REGIONAL REVIEW NOTIFICATION

ARC REVIEW CODE: R508101

Name of Proposal: 1033 Jefferson Street

Preliminary Report:	August 10, 2005	DEVELOPMENT OF REGIONAL IMPACT REVIEW REPORT	Project:	1033 Jefferson Street #783
Final Report Due:	September 7, 2005		Comments Due By:	August 22, 2005

PROPOSED SITE PLAN

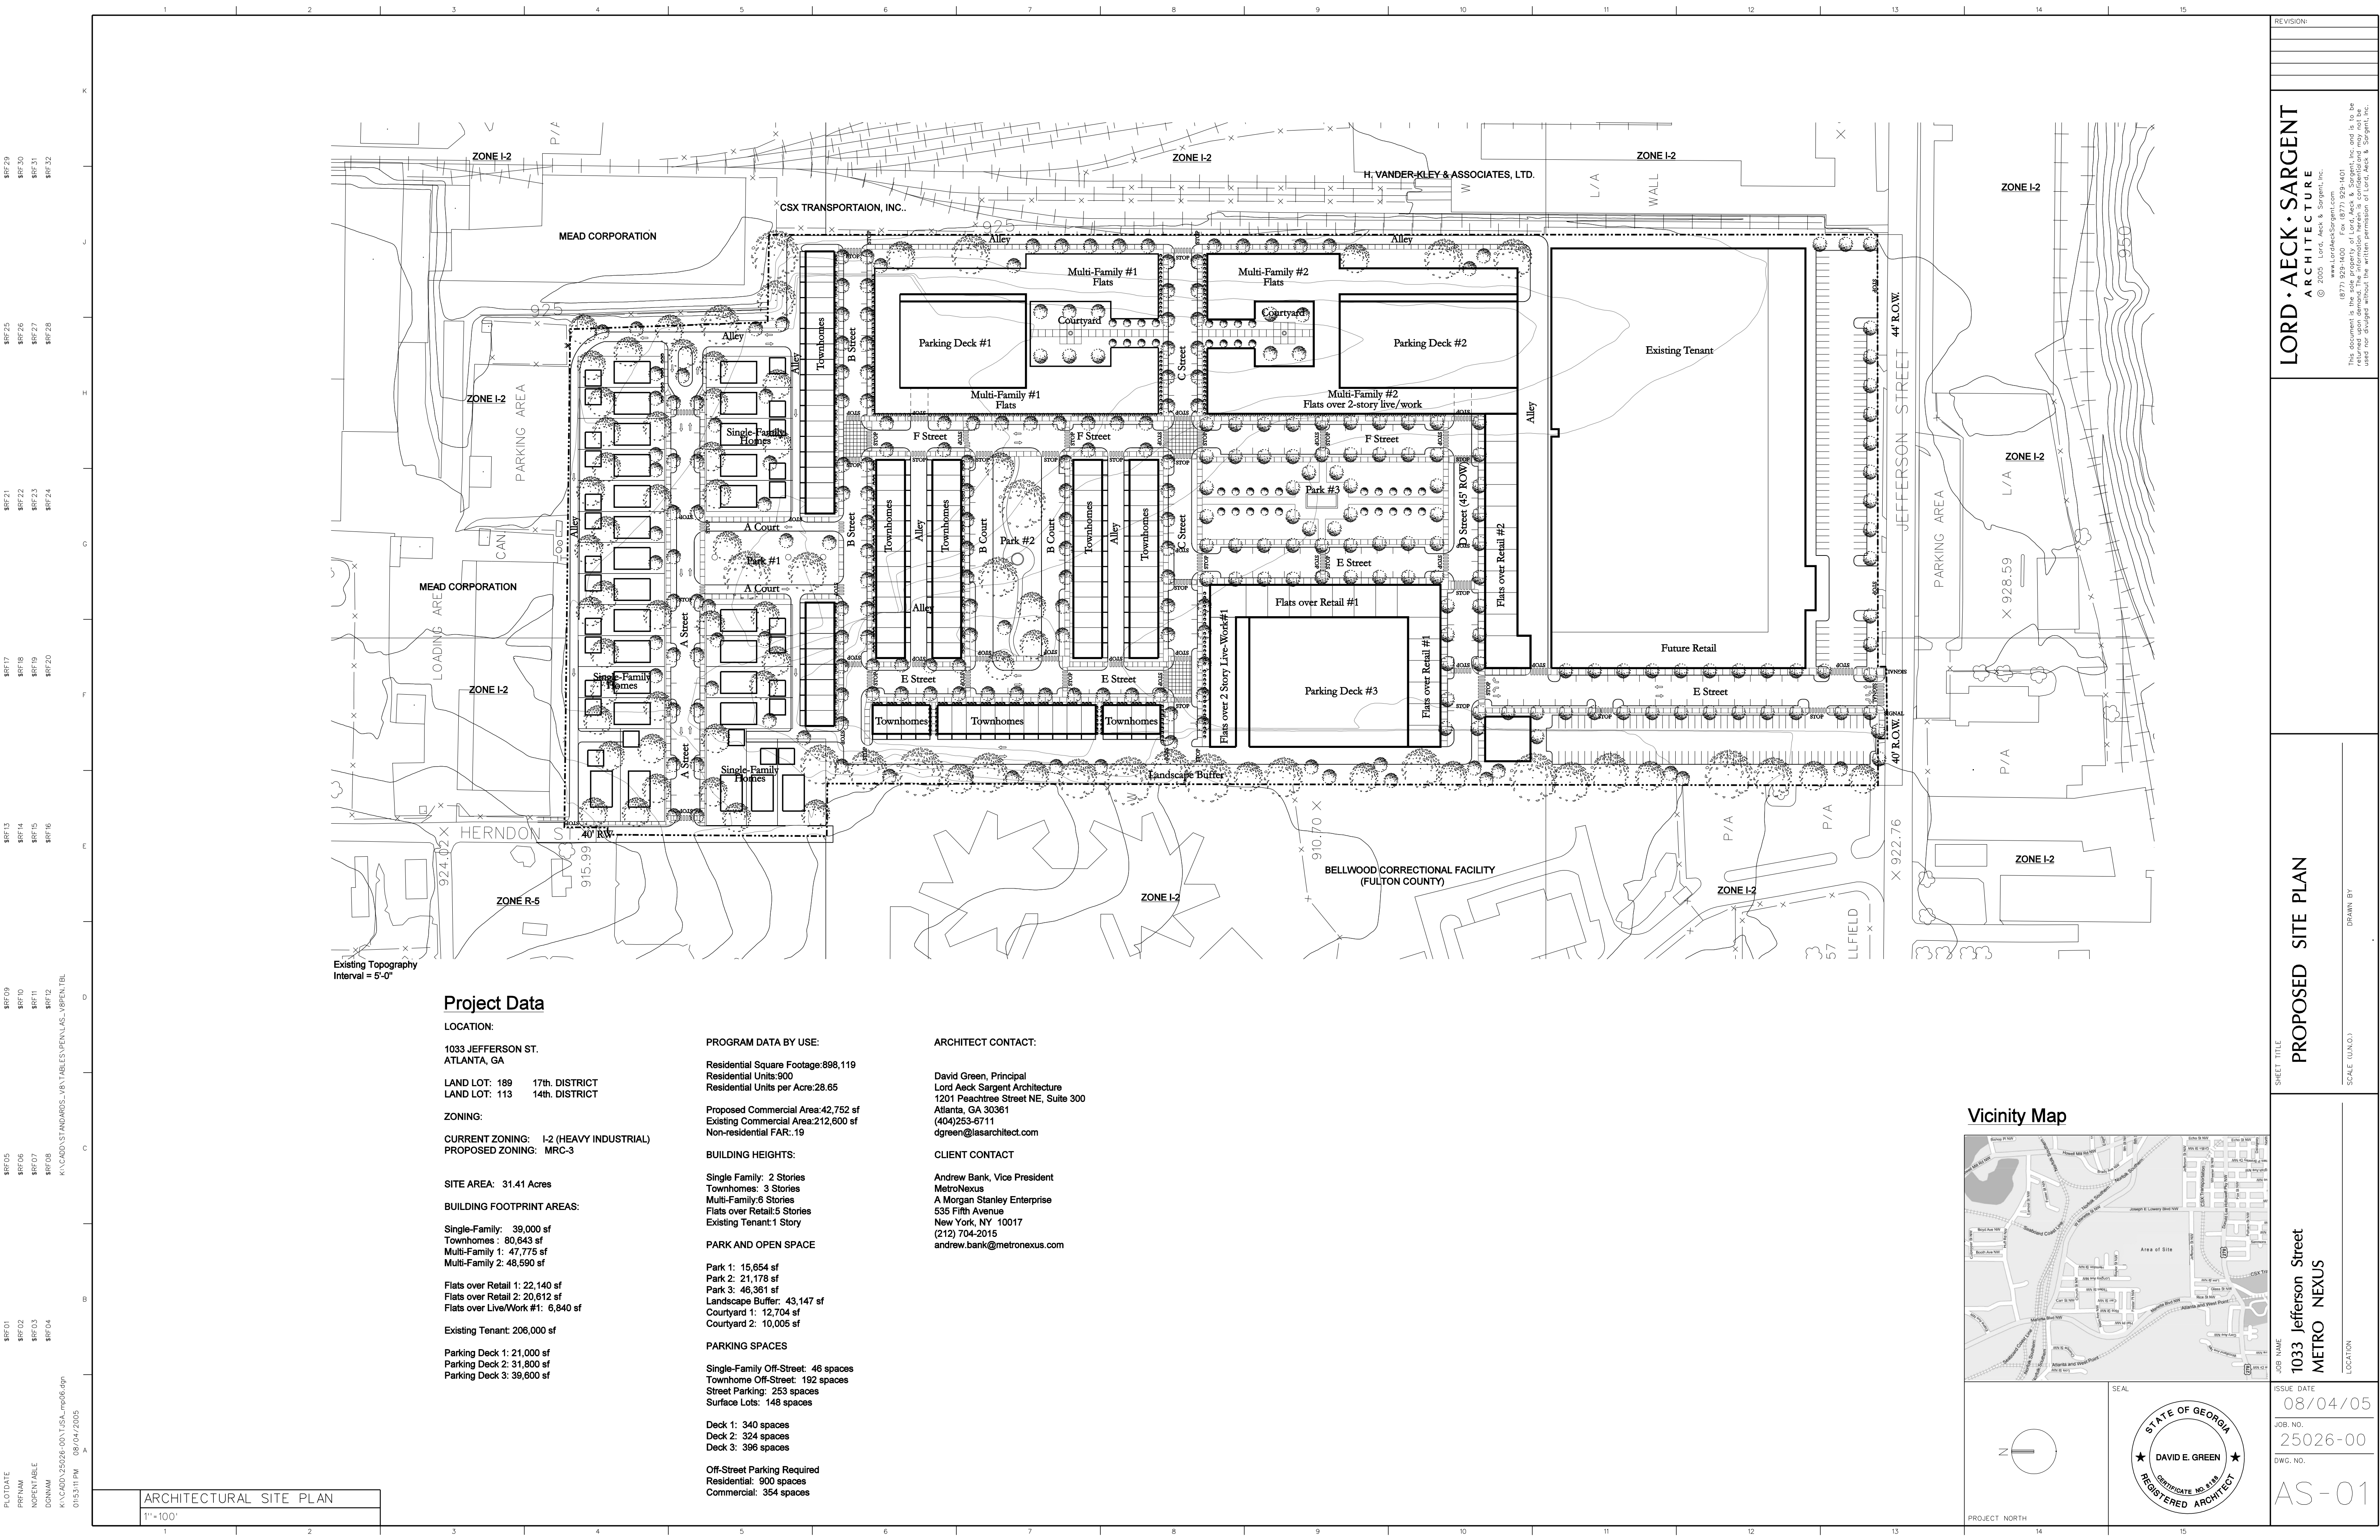
It is important to note that the proposed development is located along the proposed Beltline, for both the transit and the pathway/greenway. The proposed development should consider the proposed alignments of the Beltline, as the site plan is refined. Convenient and safe access to the Beltline should be provided.

The proposed development incorporates many several design principles that will help to create a true pedestrian oriented mixed use development. The proposed development incorporates alleys for rear parking to the townhomes, sidewalks on both sides of the street, parking decks with street front retail and commercial uses, and three separate community greenspace areas. The single family homes are proposed on small lots with parking garages located in the back of the property. Finally the proposed plan is connecting streets and alleys to the existing street system, providing multiple access points to the existing neighborhood and new commercial uses.
